RECOMMENDED SERVICE BULLETIN

RSB 40-047/4

RSB D4-052/4

„REPLACEMENT OF RH AILERON AND GMU 44 RELOCATION“

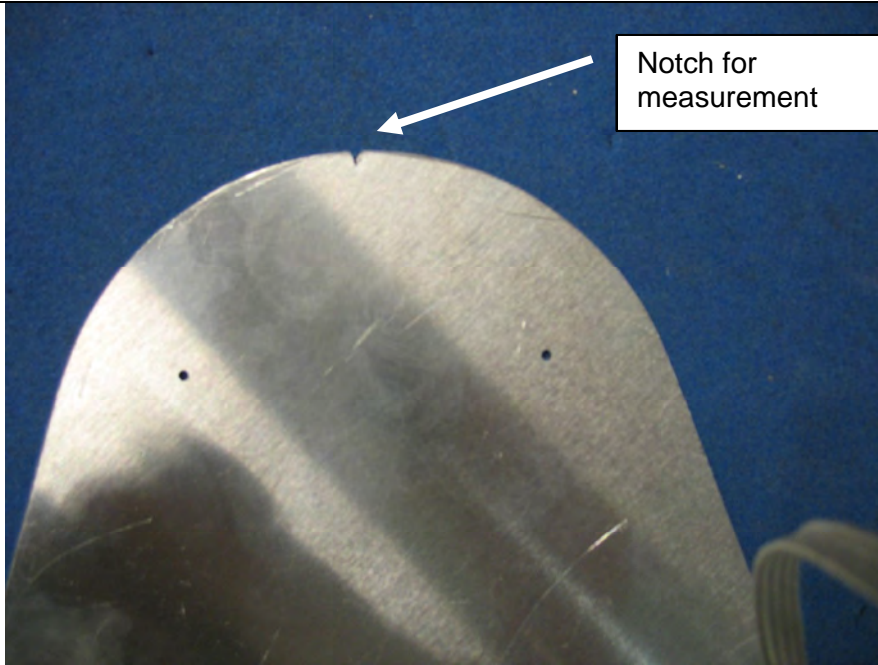
6.	Remove the GMU 44 magnetometer in accordance with the instructions given in the AMM.
7.	Replace the 4 screws of the strain relief of the GMU 44 connector and harness connector with DIN 7971-C3.5x13-A2 screws.
8.	Remove RH wing-tip.
9.	<p>Mark drillholes using marking template D4D-5741-00-SO. Refer to Drawing D4D-5741-00-00x02 and photos.</p> <p>Note: Use notch on Template for measuring.</p> <p>Caution: You must not use marking template as a drilling template!</p>

10. Drill 3 times 7.1mm hole (0.281 inch) through outer laminate of lower shell on marked positions.
11. Remove residual foam to allow the bushing fitting flush into the drillhole.
12. Try fit bushings.
13. Bond in bushings with Terostat MS 9380 and allow for curing.

14. Drill holes for screws (3,7 mm, 0.144 inch) through inner laminate.

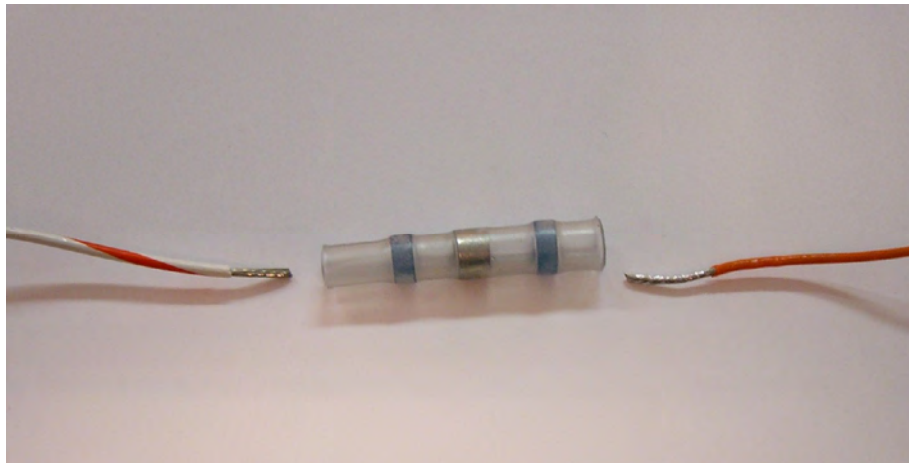
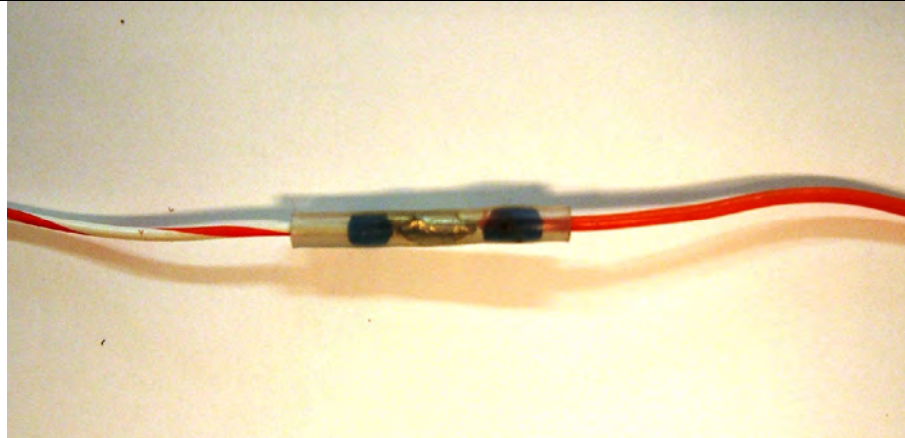
15. Extend GMU-44 harness using D4D-3143-63-00-SB harness extension.
Caution: Pay special attention to the shields and white wires (both wires are white)– refer to drawing D4D-9231-60-01.

- Disassemble the GMU connector of the aircraft harness.
- Cut-off the wires as close as possible at the connector
- Extend the cables using solder sleeves and an appropriate heat gun (refer to the photos).
